## ENGINEERING CHANGE NOTICE

1. ECN 186789

5. Project Title/No./Work Order No. HIBBE/Vapor Extraction Characterization Unit	6. Bldg./Sys./Fac. No. 216-Z Crib Sites	7. Impact Level 2 ESQ
	8. Document Numbers Changed by this ECN (includes sheet no. and rev.) WHC-SD-EN-SAD-004, Rev 0-A	9. Related ECN No(s). 169357	10. Related PO No. N/A
11a. Modification Work <input type="checkbox"/> Yes (fill out Blk. 11b) <input checked="" type="checkbox"/> No (NA Blks. 11b, 11c, 11d)	11b. Work Package No. N/A	11c. Modification Work Complete N/A _____ Cog. Engineer Signature & Date	11d. Restored to Original Condition (Temp. or Standby ECN only) N/A _____ Cog. Engineer Signature & Date

Safety Assessment for the 200 West Area Expedited Response Action for Remediation of Carbon Tetrachloride

Figure 11. CCl<sub>4</sub> Vapor Extraction System Characterization Unit.

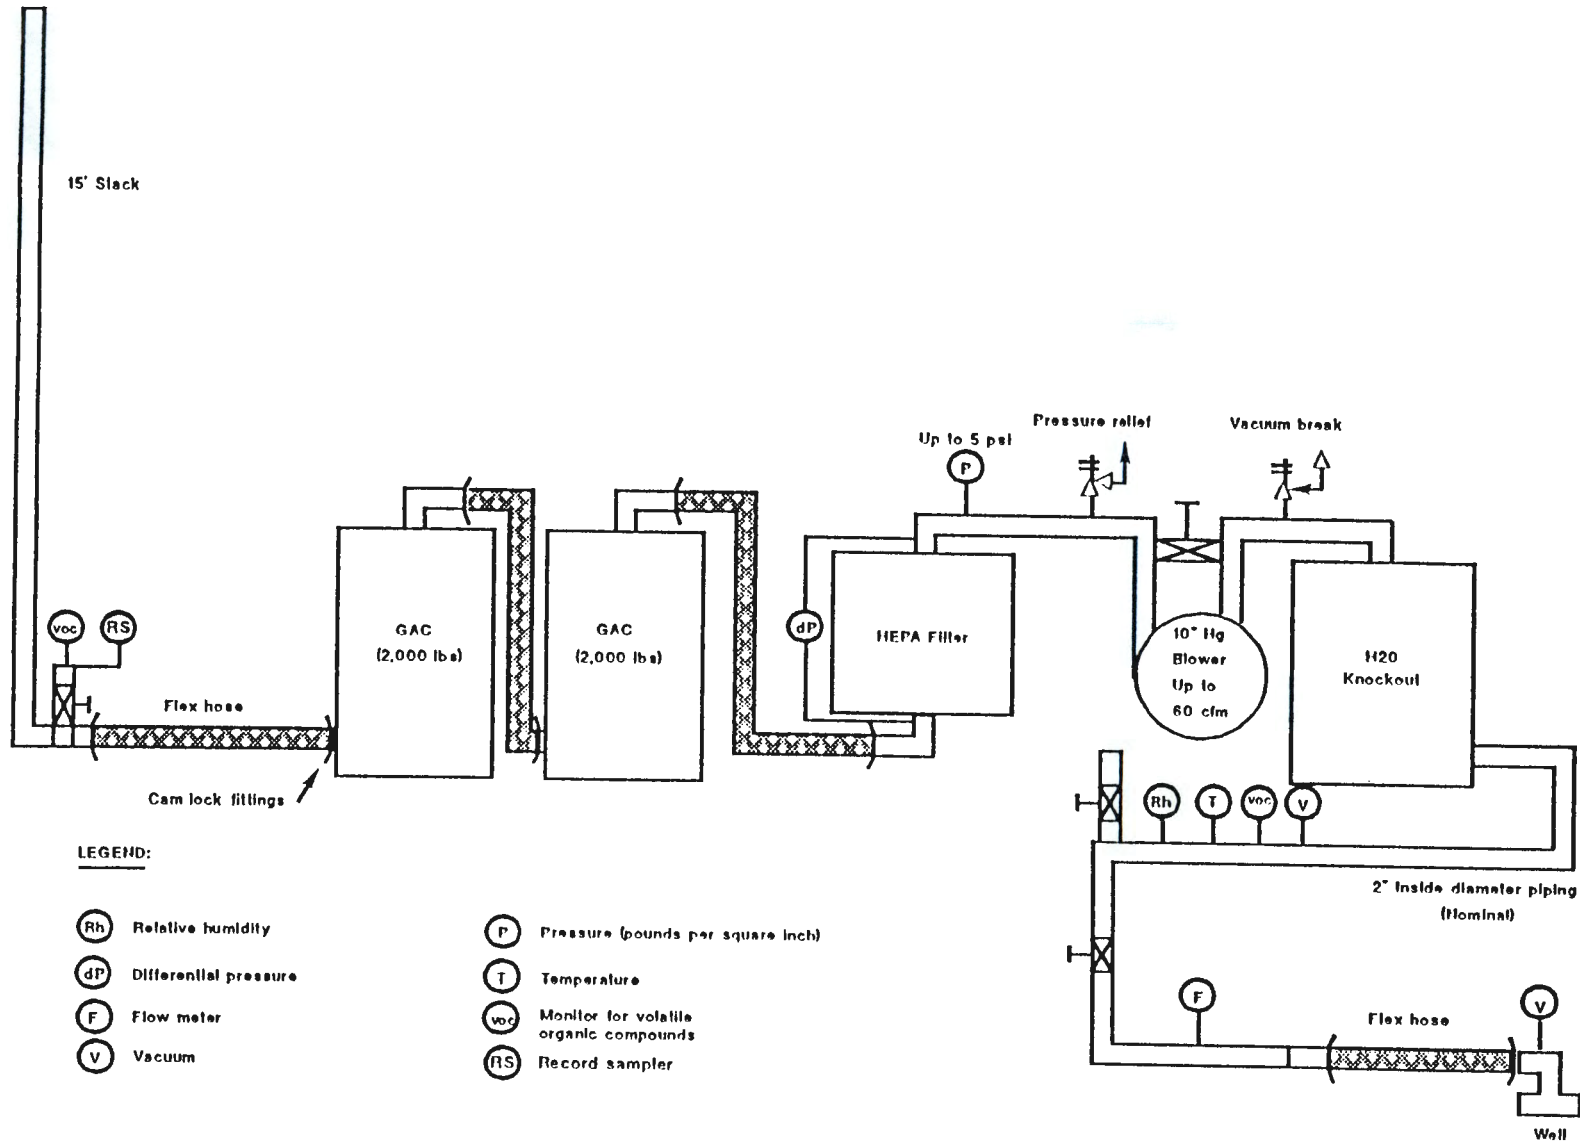
0-B	Replace pages 25 and 26; Figure 11 has been inserted.			
0-B	Replace page 27; reference has been revised.			
0-B	Replace pages 28, 29, and 30; new page numbers.			
0-B	Replace page 31; reference has been revised.			
0-B	Replace pages 32 and 33; references have been revised.

A description of the specific components for the VES characterization unit is provided in Figure 11.
